## ADDENDUM NO. 04

MOUNTAIN TRANSIT MAINTENANCE FACILITY

**FOR THE**  
MOUNTAIN AREA REGIONAL TRANSIT AUTHORITY (MARTA)

RCA Project No. 5-08-01

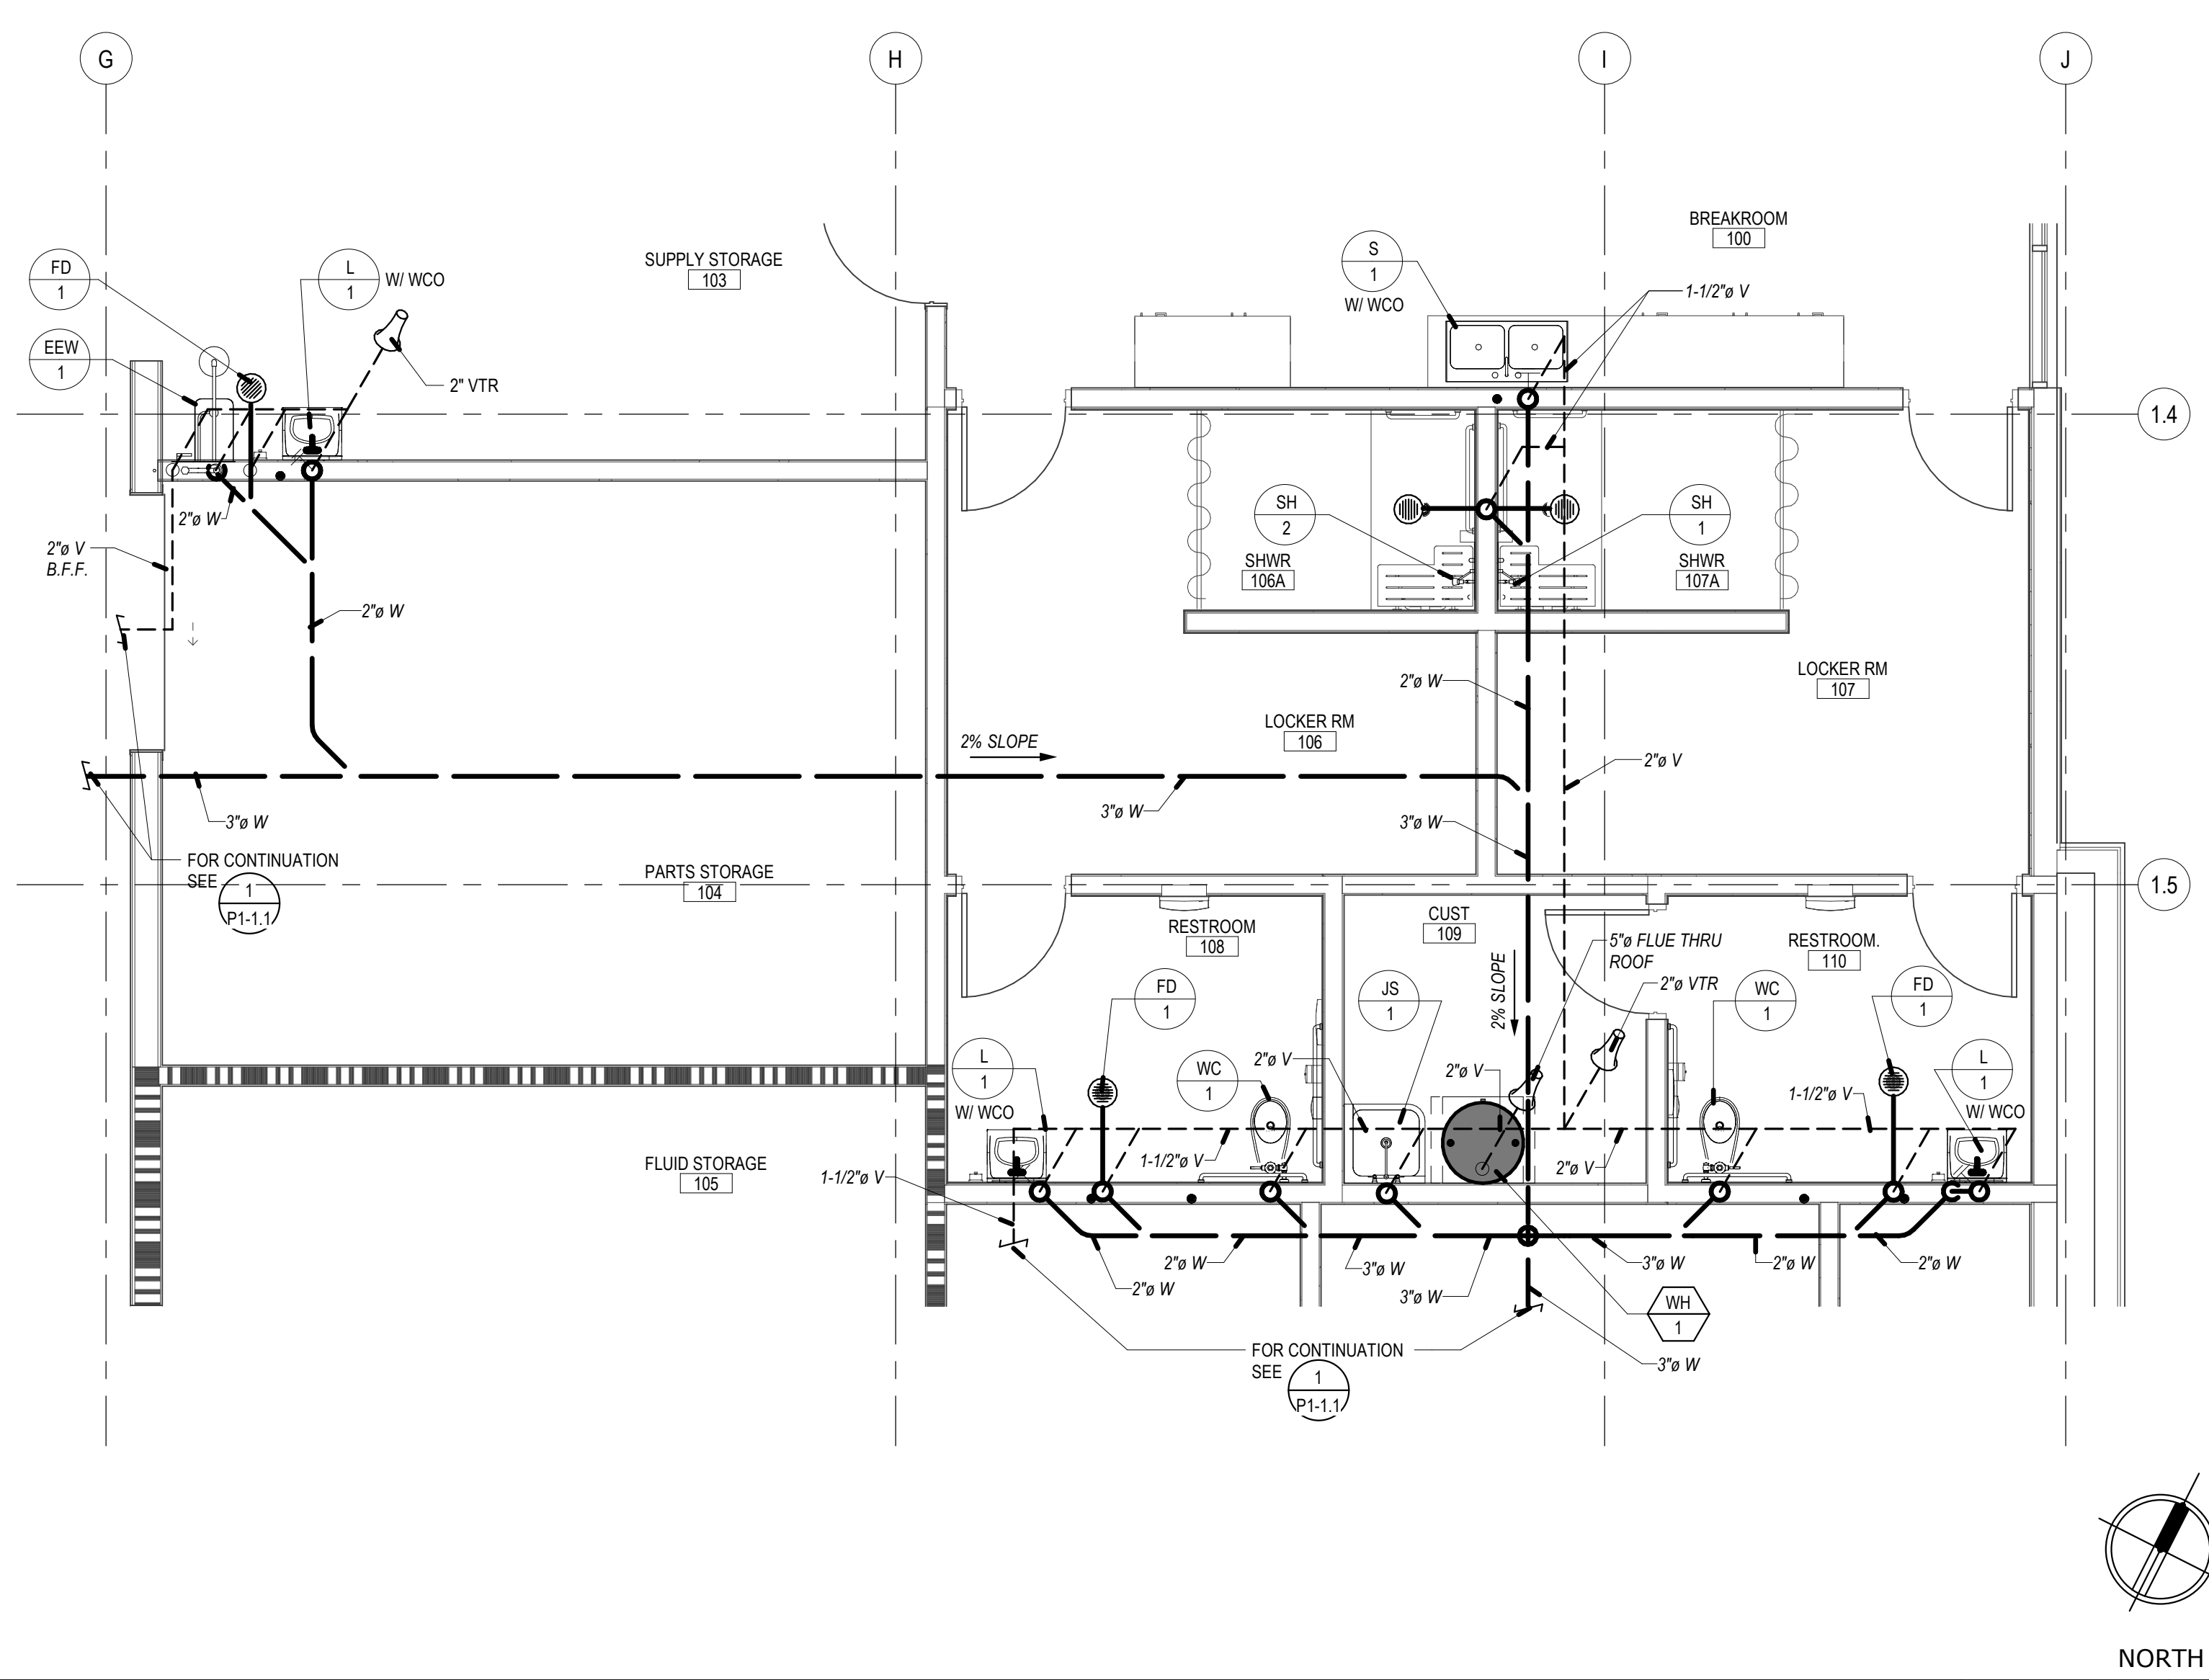
b) Revised Construction Notes per clouded area.  
a. Added construction notes 27 and 28.  
b. Revised construction notes 20, 21, 26.  
c) Revised Plumbing Floor Plan – Domestic Water, Compressed Air & Gas 1/P1-1.2 per clouded area.

a. Added lube piping from fluid storage tank in the Fluid Storage Room 105 to the hose reels in the Mechanic Bays.  
b. Moved floor drain in Mechanics Bay 1.

PANELBOARD/ TERMINAL CABINET ANCHORAGE-FLUSH N.T.S. 3

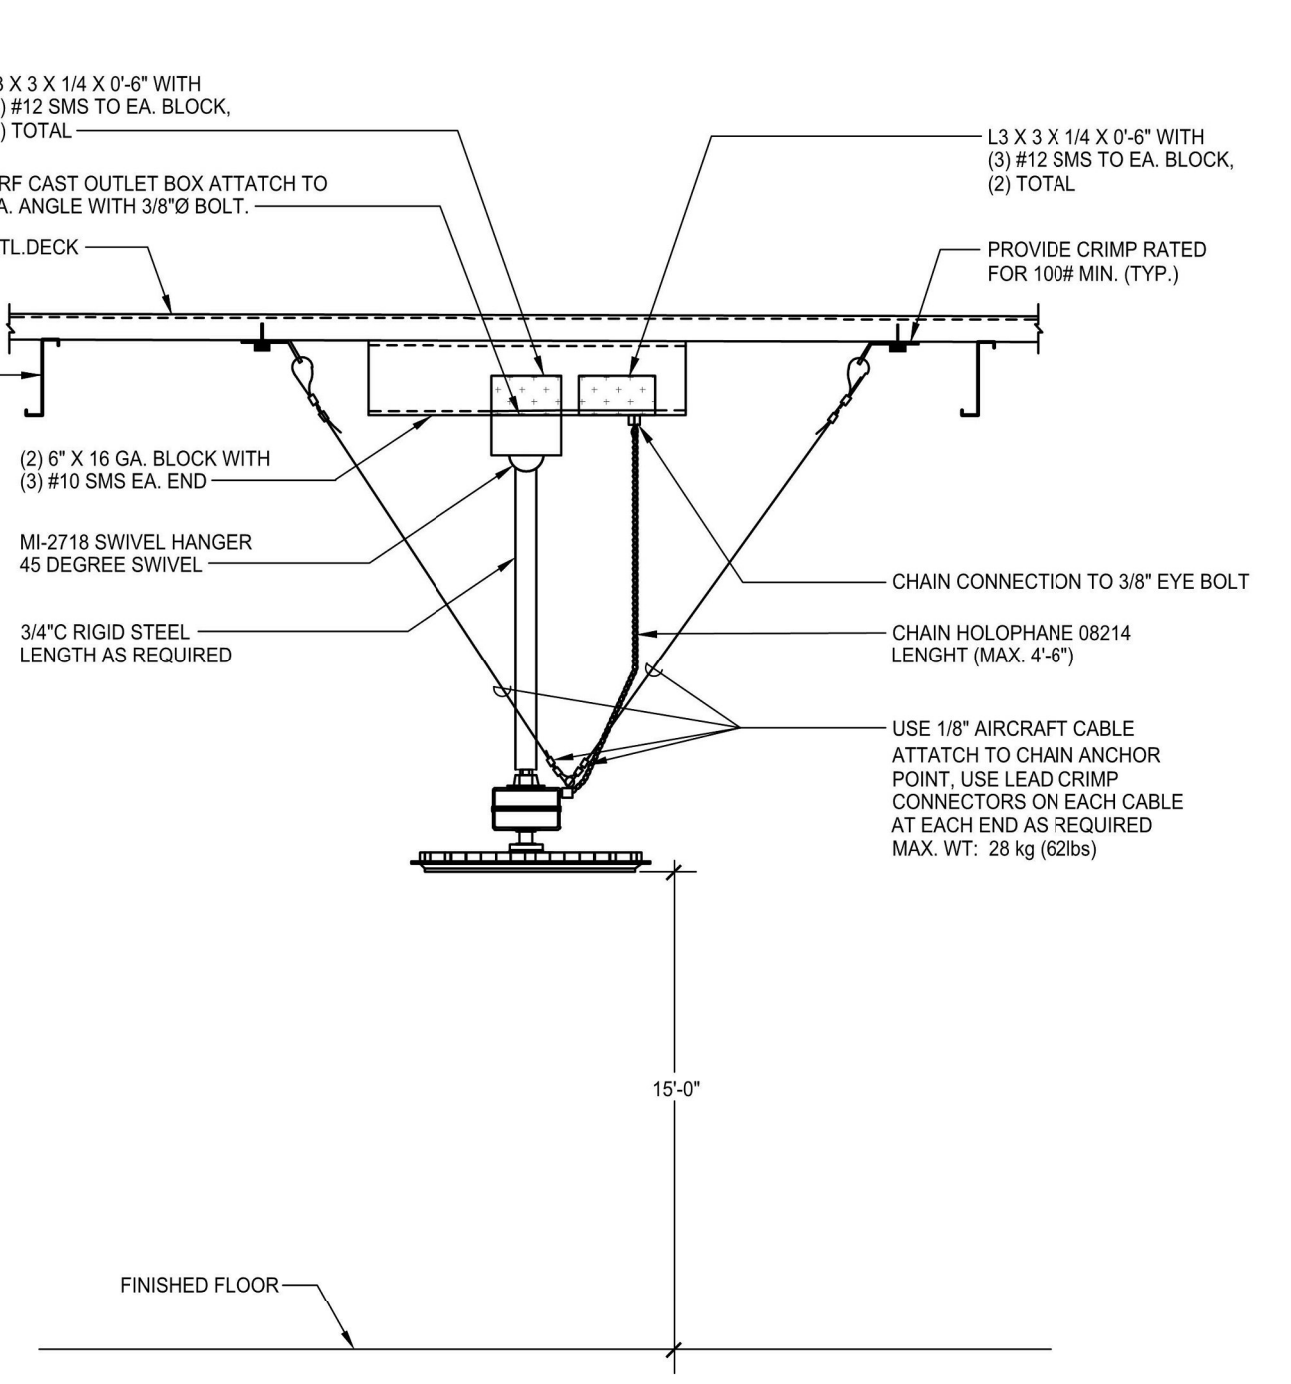
- a) Revised Details 3/E1-0.2 per clouded areas.
  - b) Revised Detail 4/E1-0.2 per clouded areas
- Item No. 4.39 Reference Sheet E1-0.3 – Single Line Diagram and Lighting Fixture Schedule

**SIGNAL PLAN AND FIRE ALARM PLANS** 1/8" = 1'-0" 1

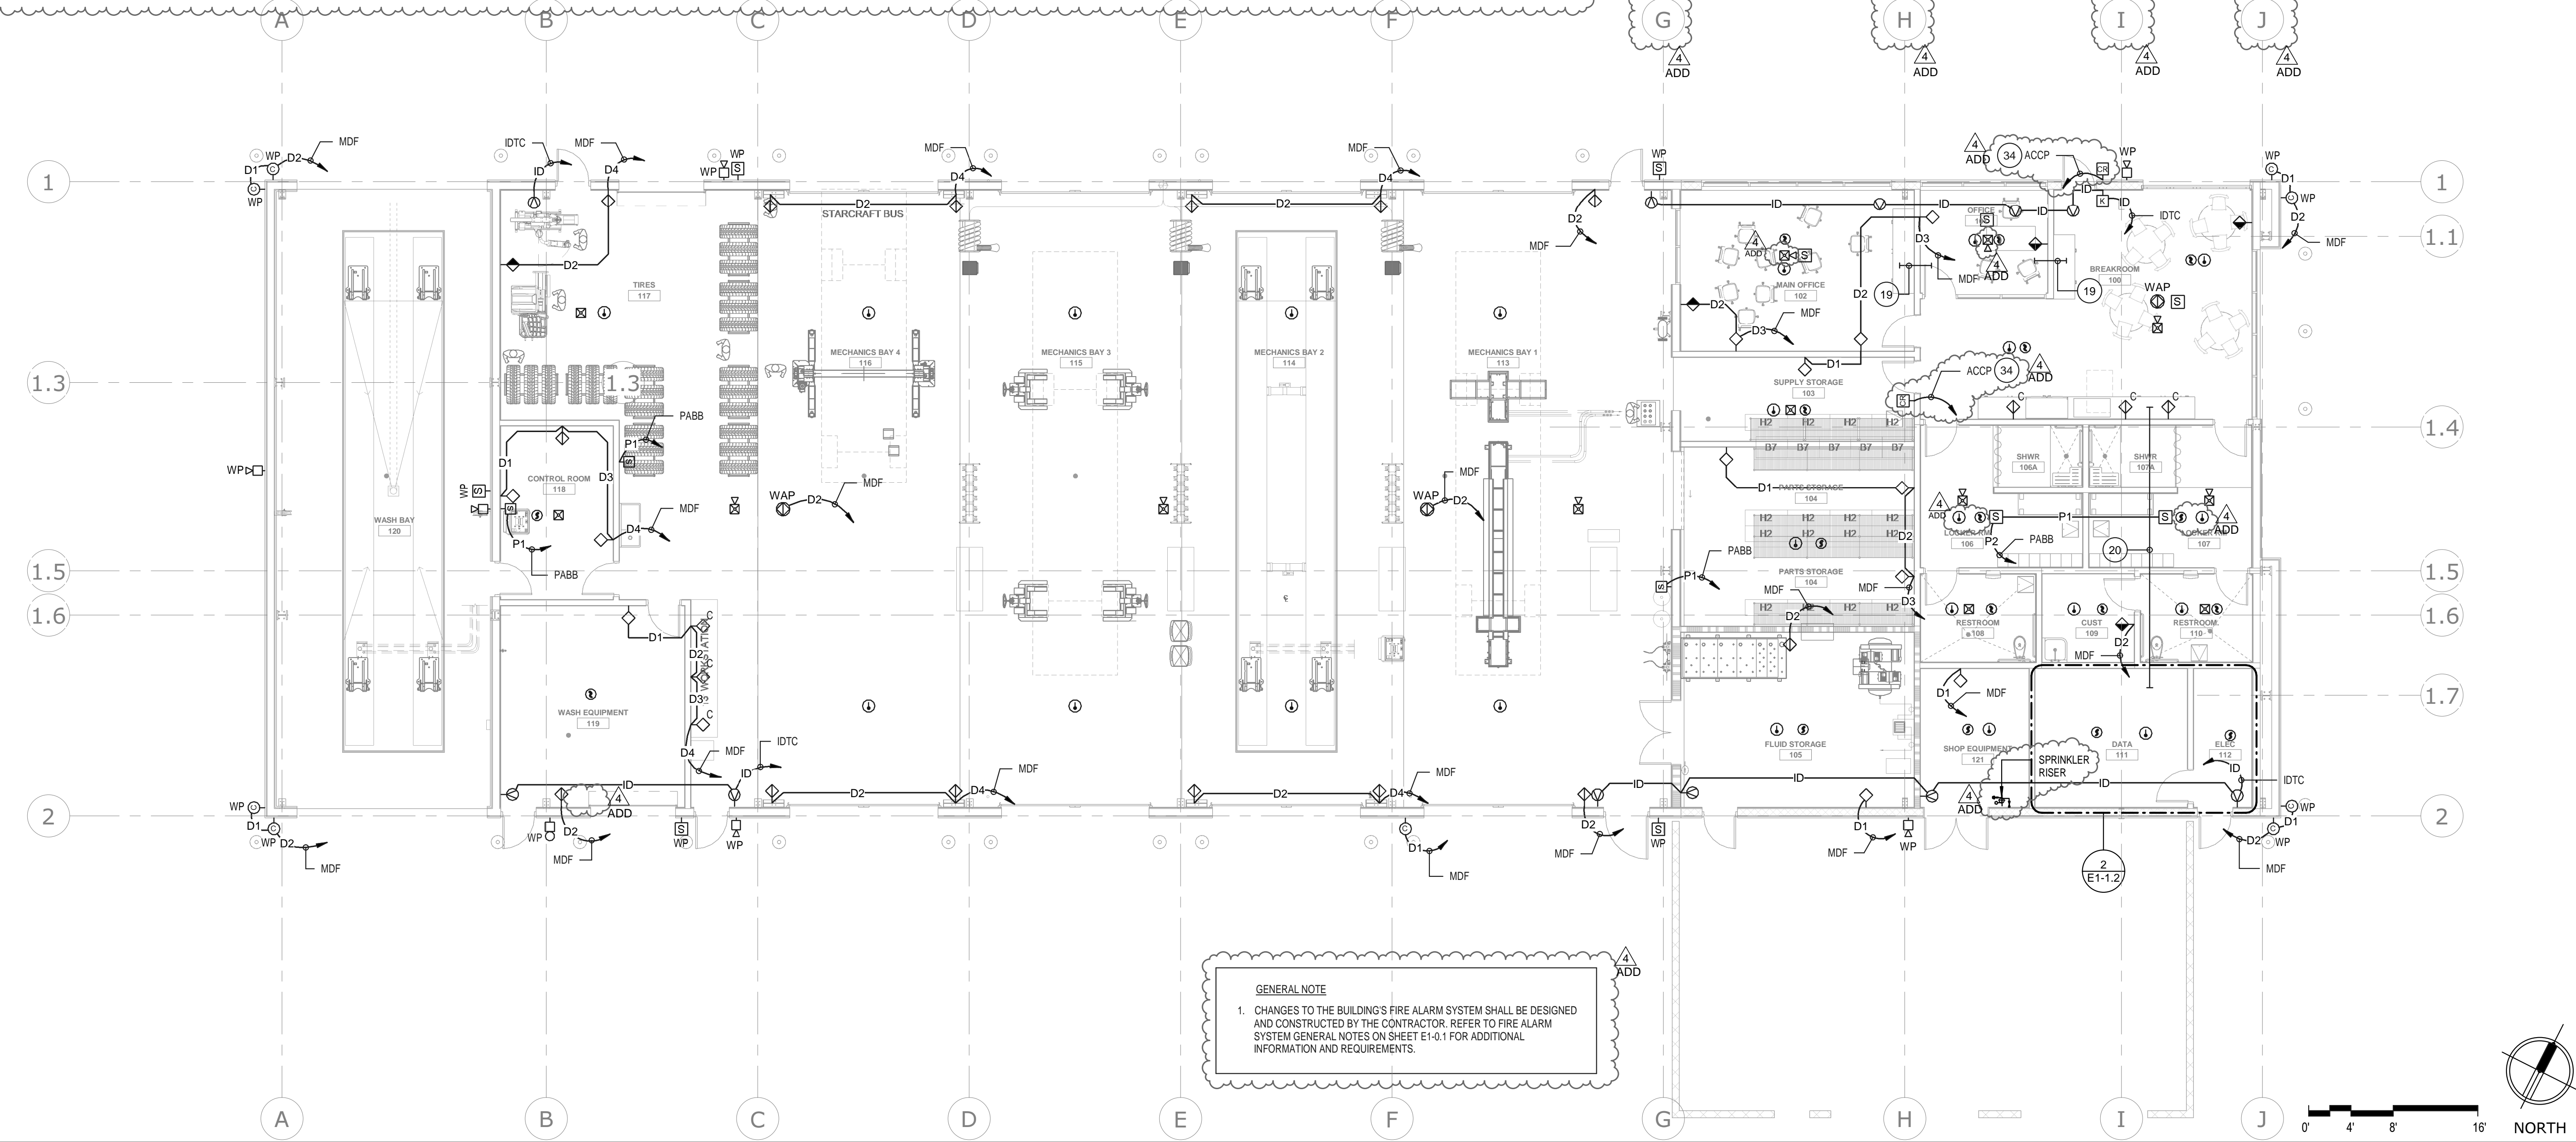
- Item No. 4.41 Reference Sheet E1-1.2 – Panel Schedules
- 4.41.1 Replace Sheet E1-1.2 and revise per clouded areas listed below:
    - a) Revised detail 1/E1-1.2 per clouded areas.

- a. Added card reader on doors of break room 100.
      - b. Revised smoke and heat detectors in Locker Rooms.
      - c. Indicated fire sprinkler riser.

- d. Indicated Grid Lines “G”, “H”, “I” and “J”.
    - b) Revised detail 2/E1-1.2 per clouded areas.
      - a. Added access control system controller and power supply.

- b. Added detail reference to Ufer Ground.
      - c. Added Grid Lines “I” and “J”.
    - c) Added Plan Notes per clouded areas.
      - a. Added Plan Note #21
